Addendum No. 3
August 2, 2024

Project: Brandon Valley Elementary School
Brandon, South Dakota
Project #3023

Architect: Architecture Incorporated

ENLARGED SITE PLAN - SOUTH PARKING

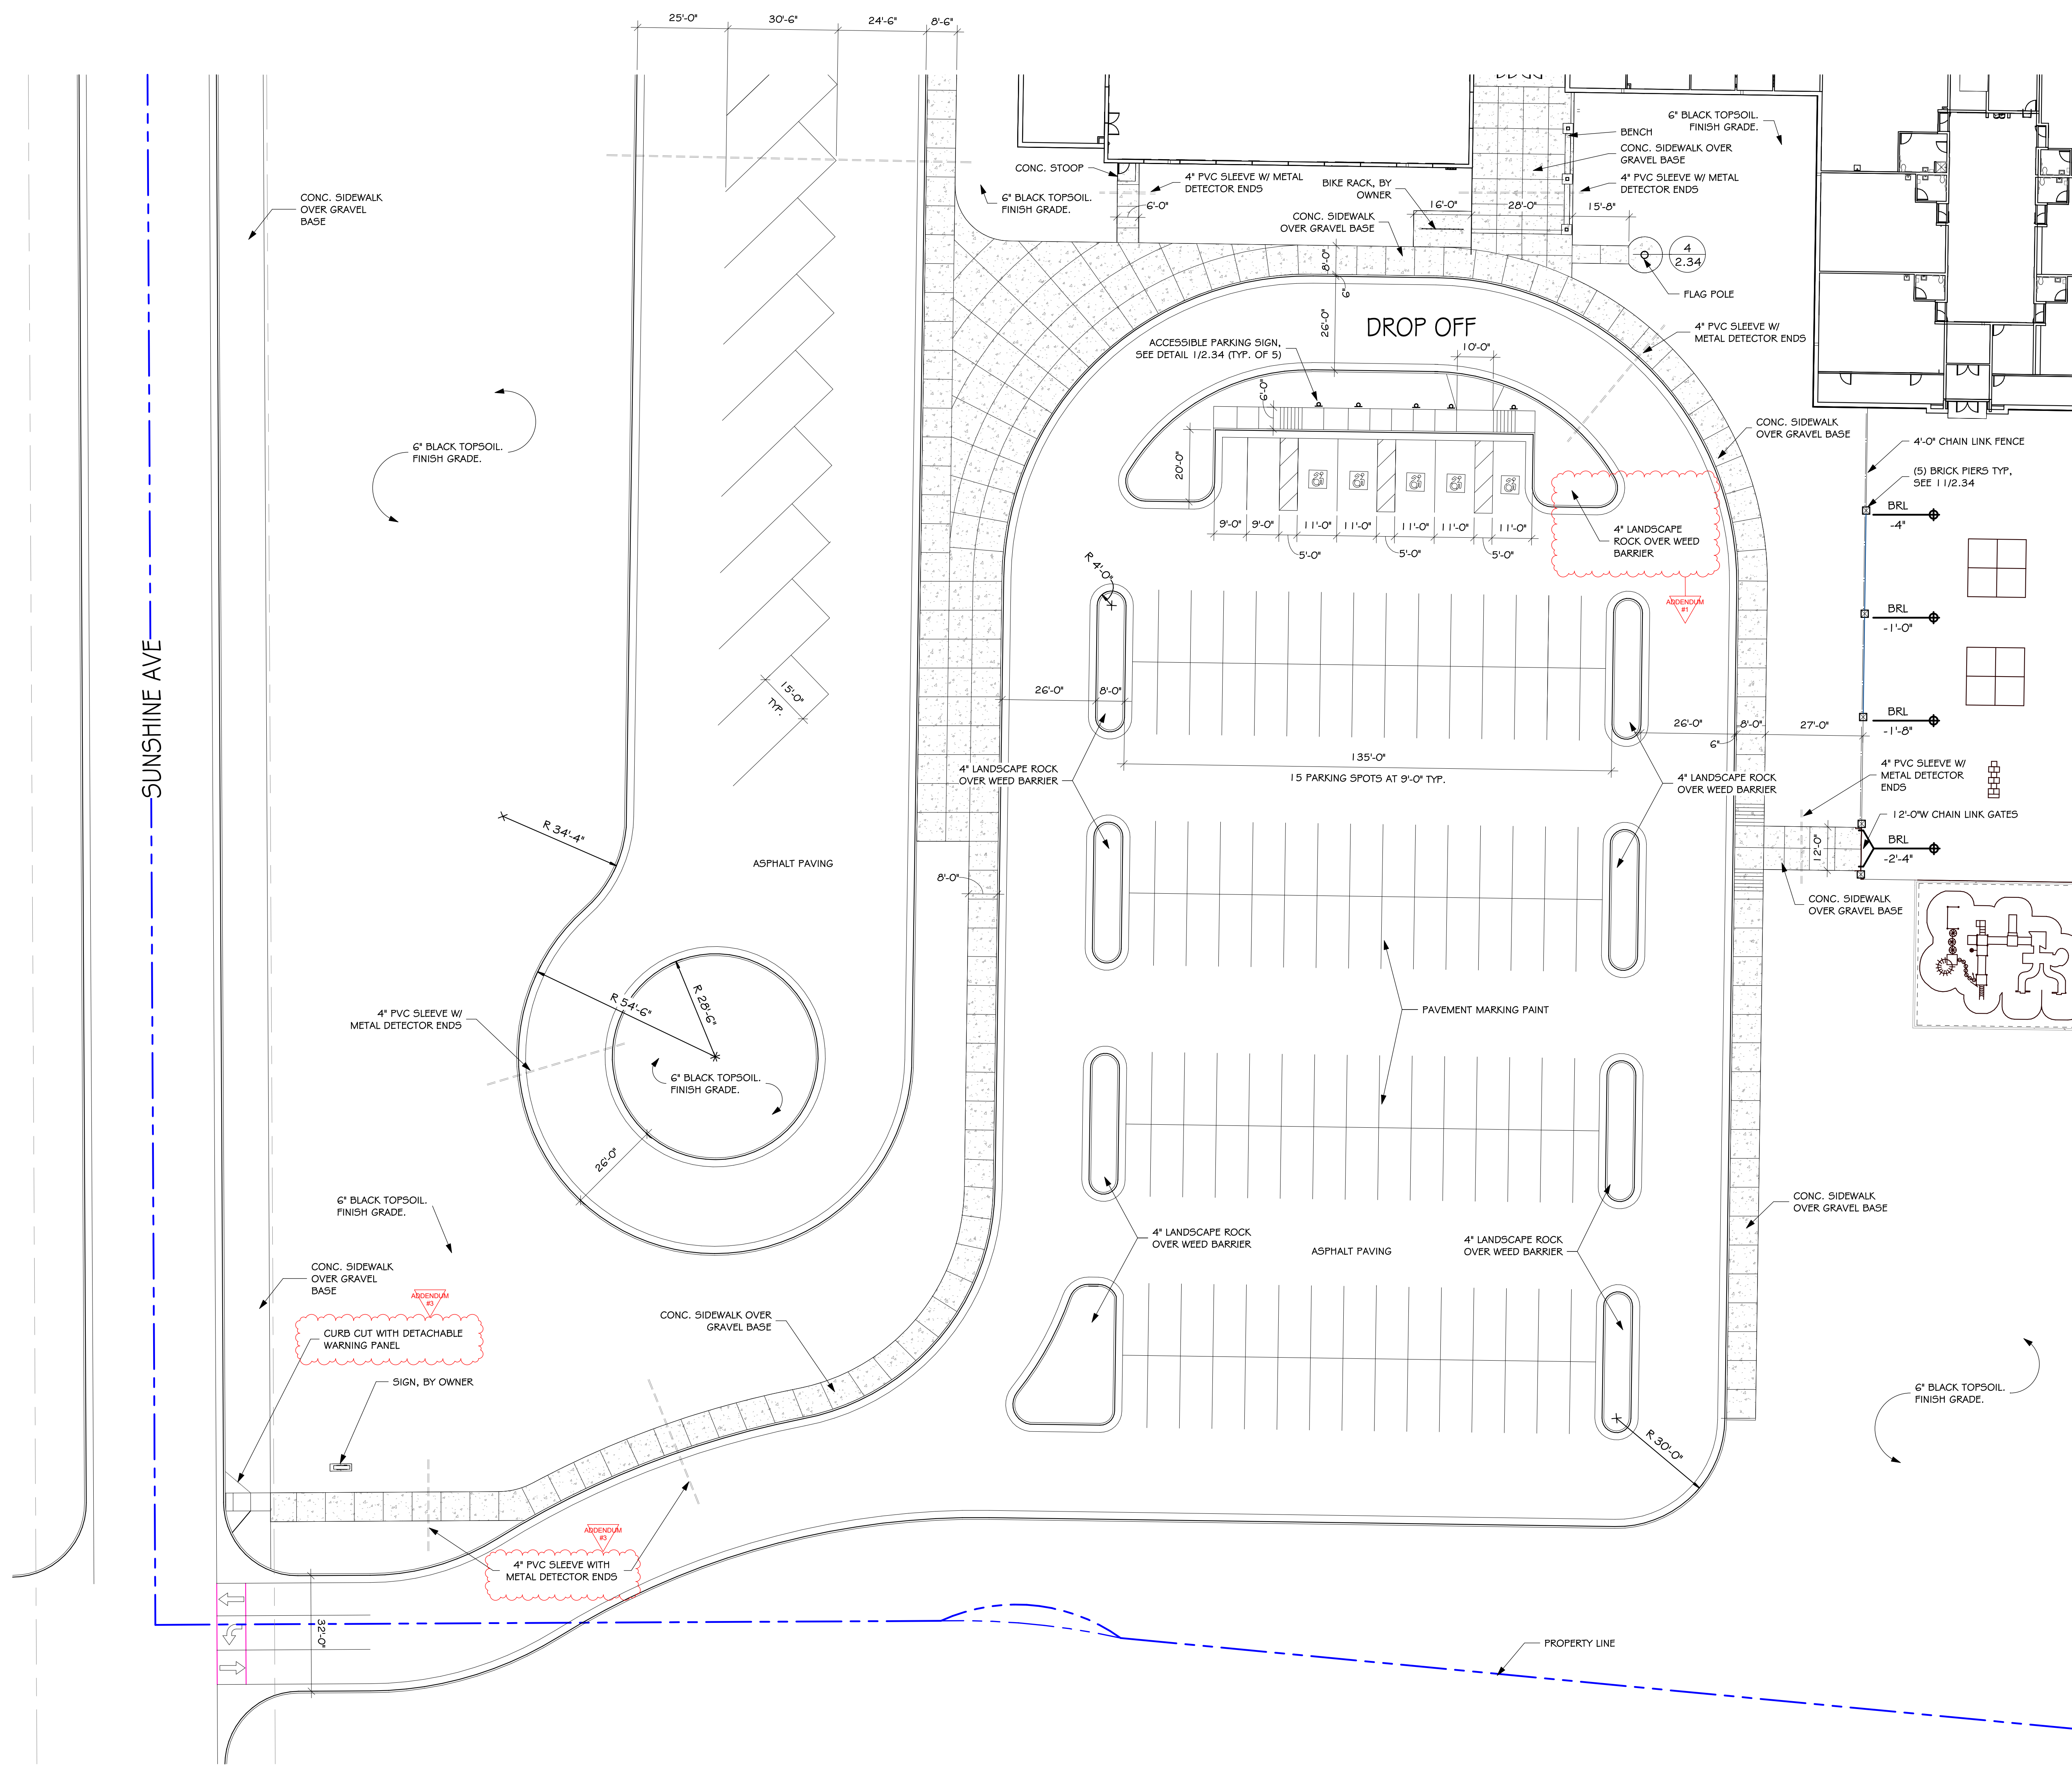
- 8) SHEET 2.31 – ENLARGED SITE PLAN – SOUTH PARKING
- a) Reference *revised* Sheet 2.31, *revision* dated 8-2-2024, attached to the end of Addendum #3 for following modifications:

ENLARGED SITE PLAN - WEST PARKING

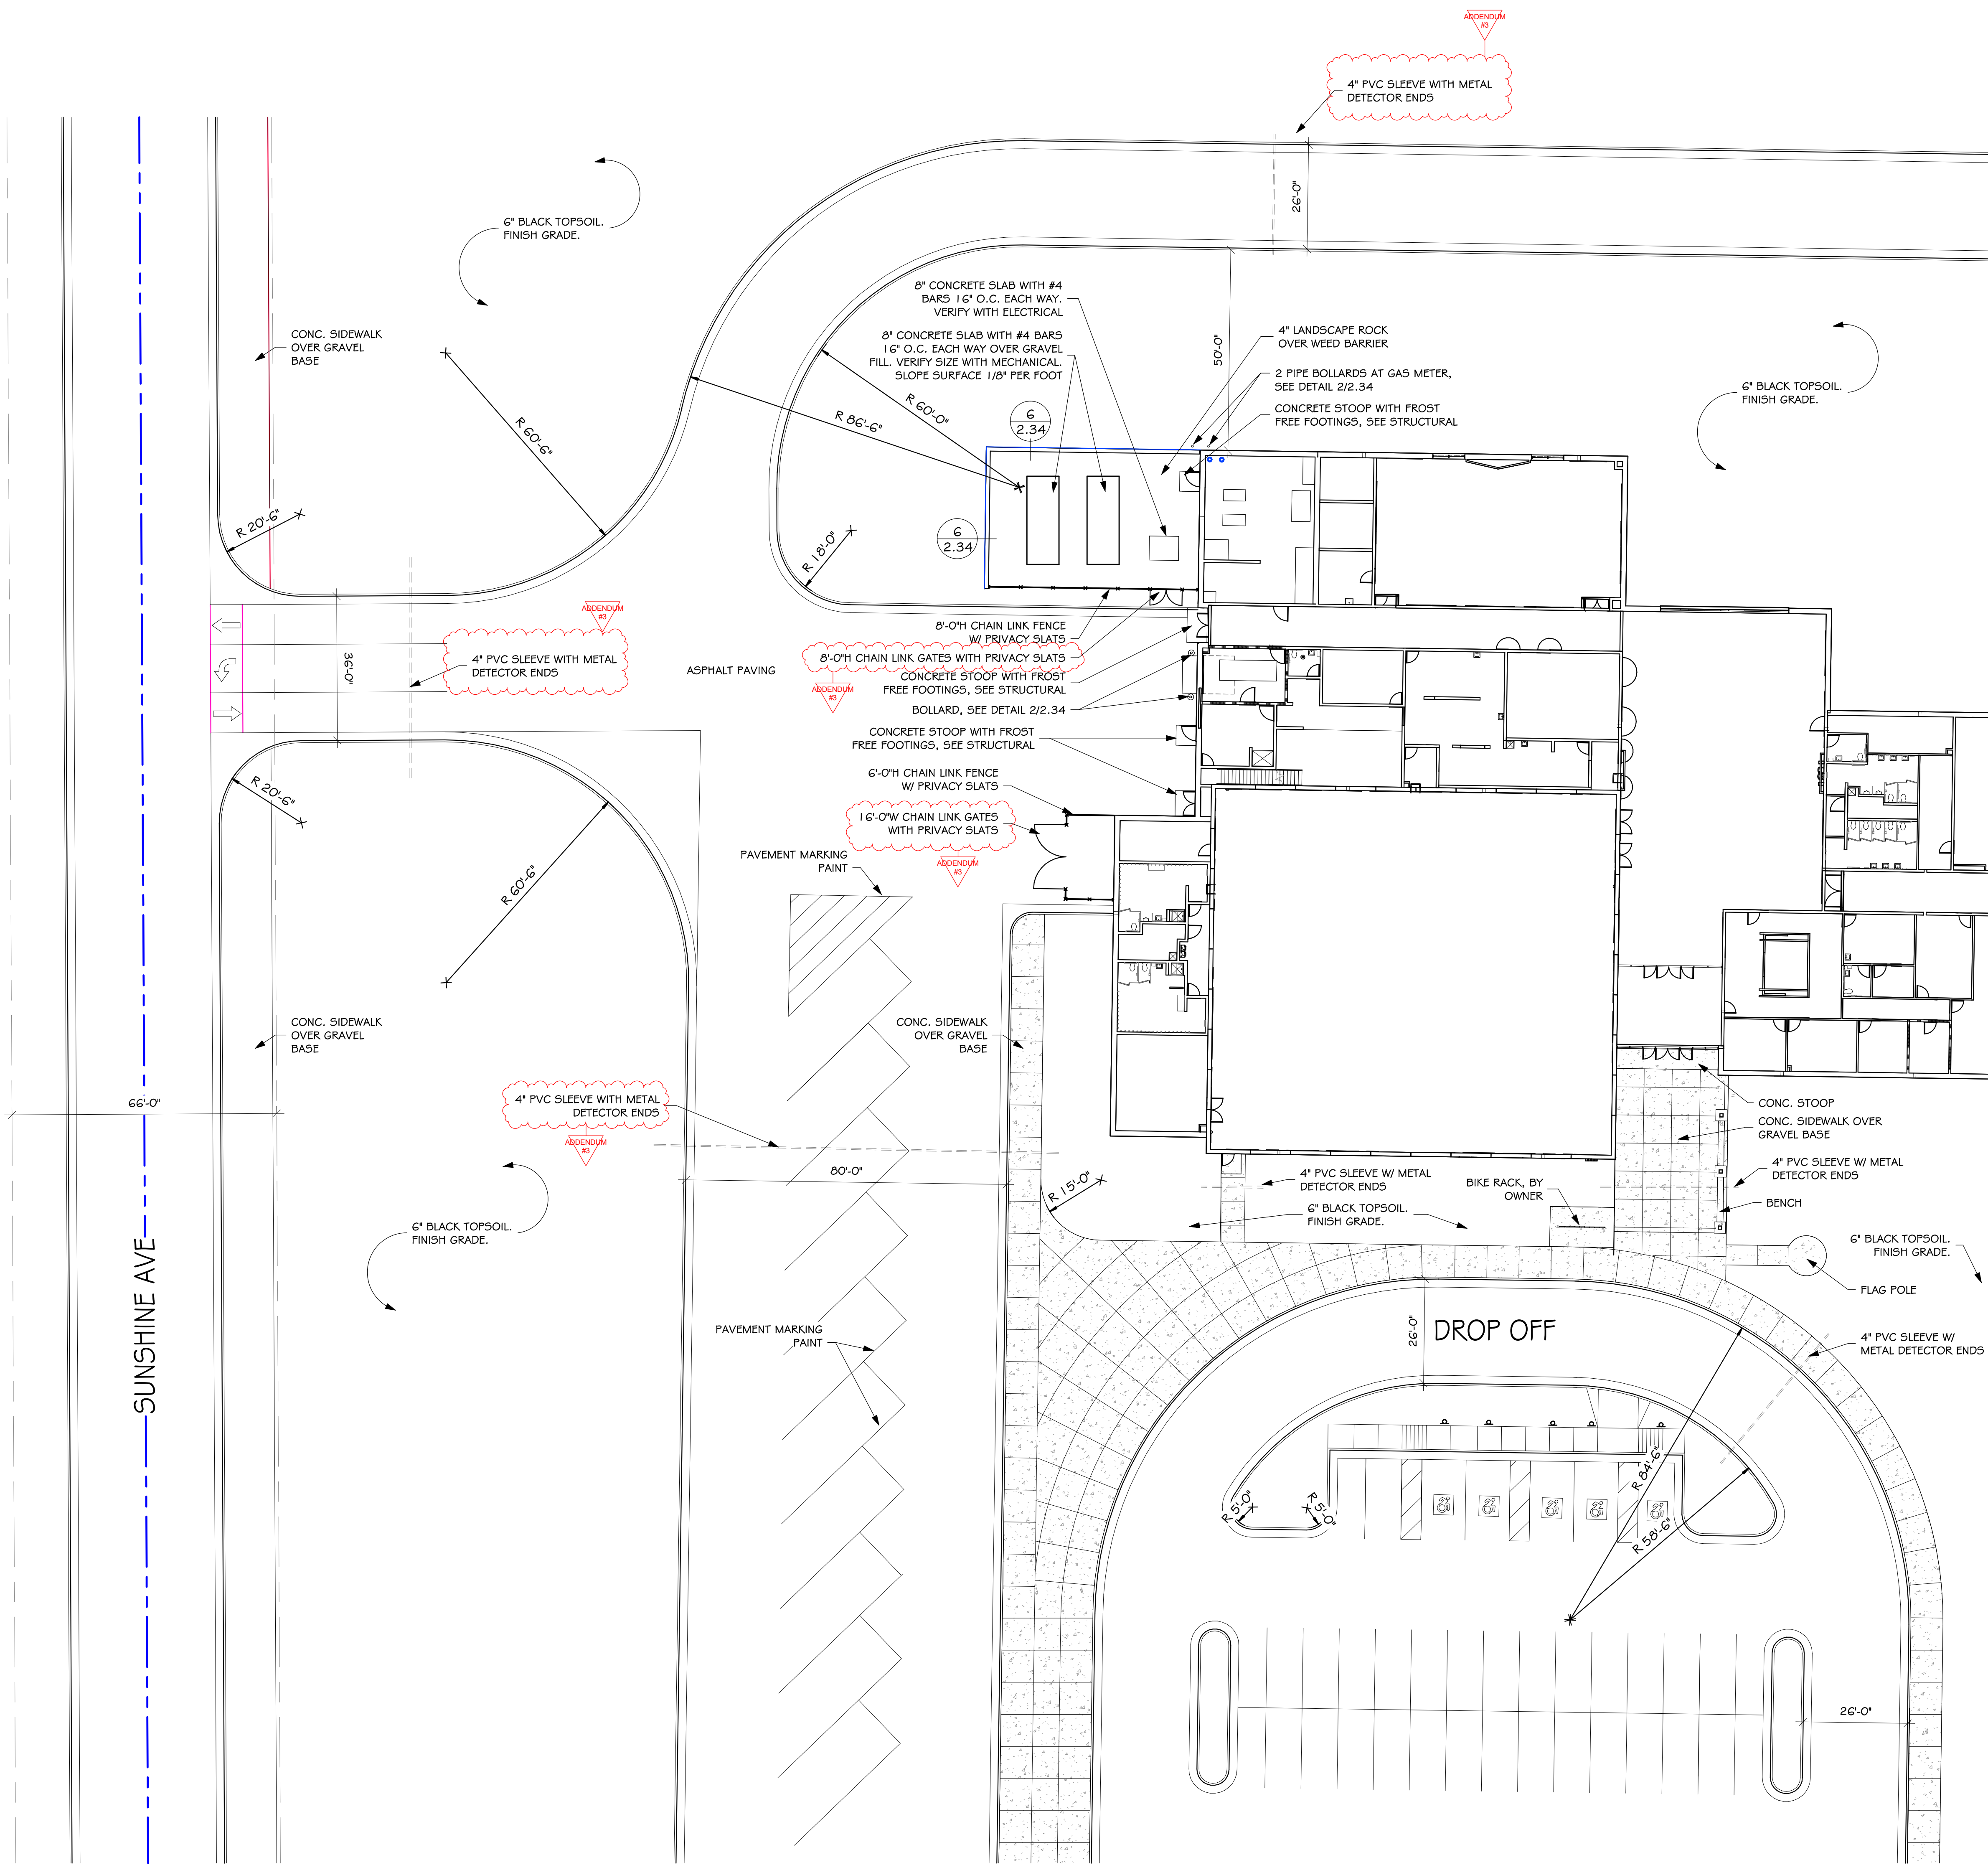
- 9) SHEET 2.32 – ENLARGED SITE PLAN – WEST PARKING
- a) Reference *revised* Sheet 2.32, *revision* dated 8-2-2024, attached to the end of Addendum #3 for following modifications:

- iii) Furnish and install 16'-0" wide by 6'-0" high chain link gates with *privacy slats* at trash enclosure as indicated.
- 10) SHEET 2.33 – ENLARGED SITE PLAN – SOUTH PLAYGROUND

1 FOOTING AND FOUNDATION PLAN - AREA C
3.13 1/8" = 1'-0"

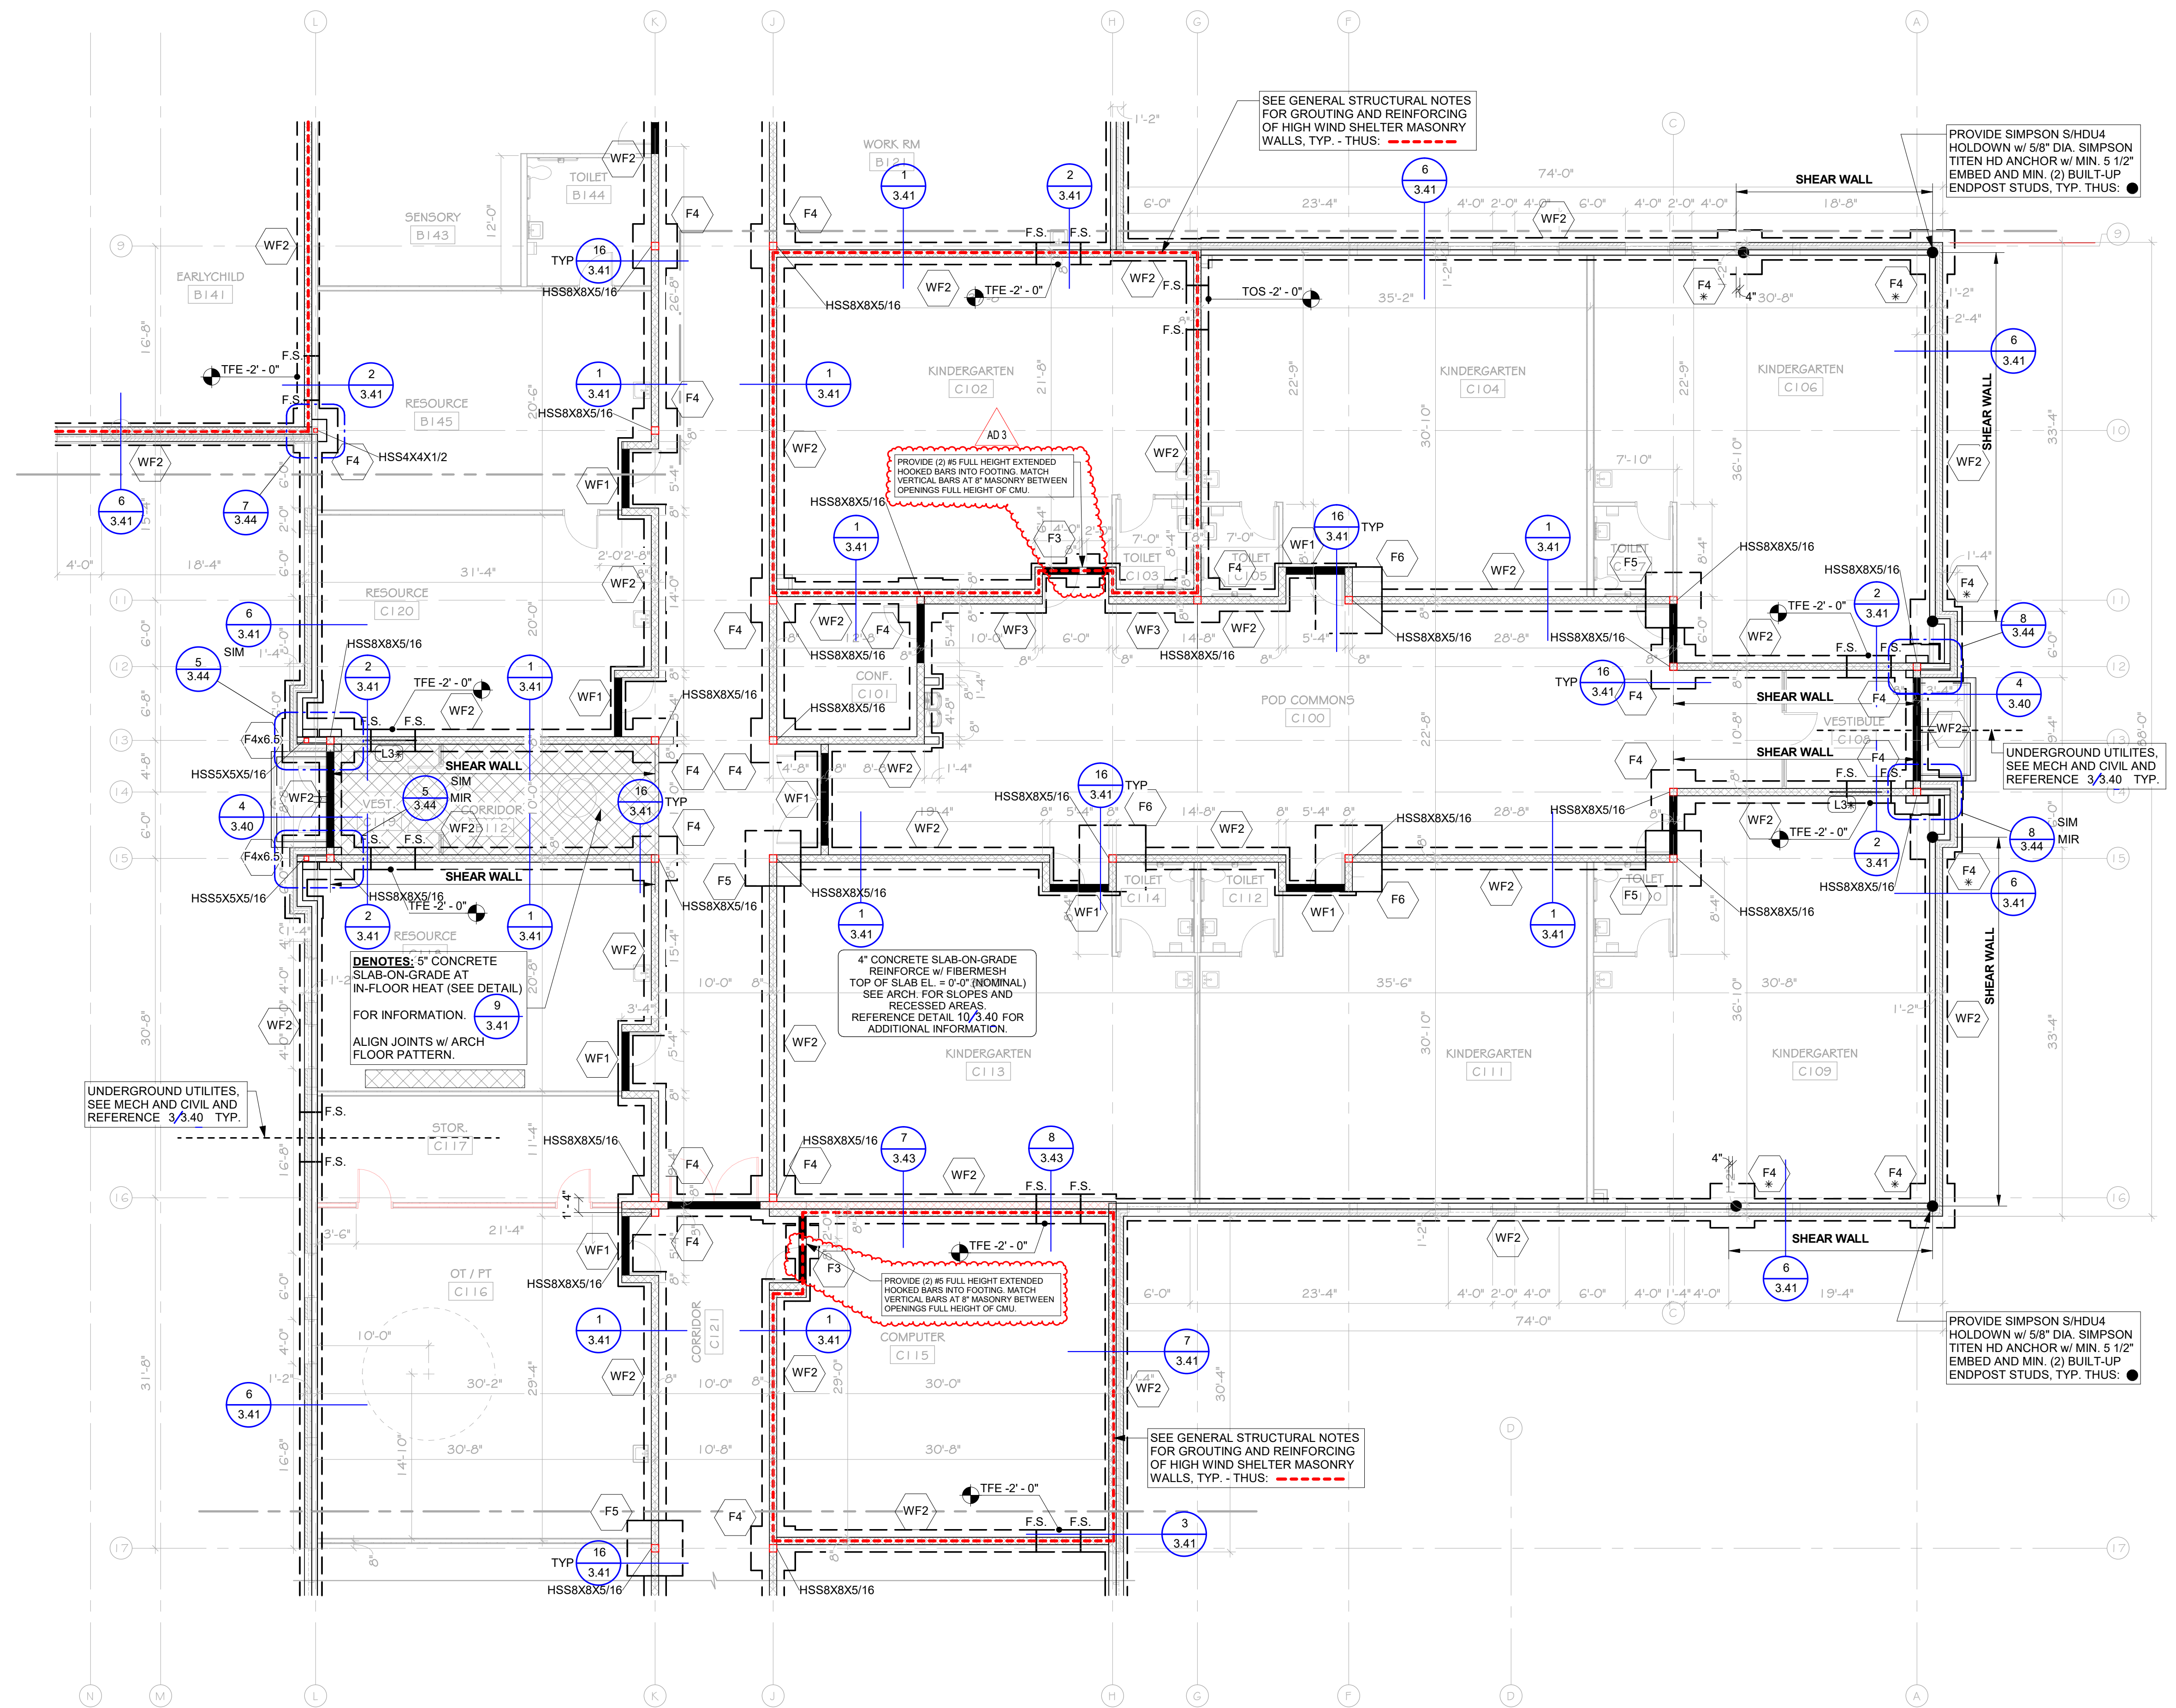
14) SHEET 3.13 – FOOTING AND FOUNDATION PLAN – AREA C

- a) Reference *revised* Sheet 3.13, *revision* dated 8-1-2024 attached to the end of Addendum #3 for the following modifications:
 - i) Remove 8x8X5/16" column between sidelight and door C102 as indicated. Provide (2) #5 full height extended hooked bars into footing. Match vertical bars at 8" masonry between openings full height as noted.
 - ii) Provide F3 pad footing as indicated.
 - iii) Remove 8x8X5/16" column between sidelight and door C115 as indicated. Provide (2) #5 full height extended hooked bars into footing. Match vertical bars at 8" masonry between openings full height as noted.
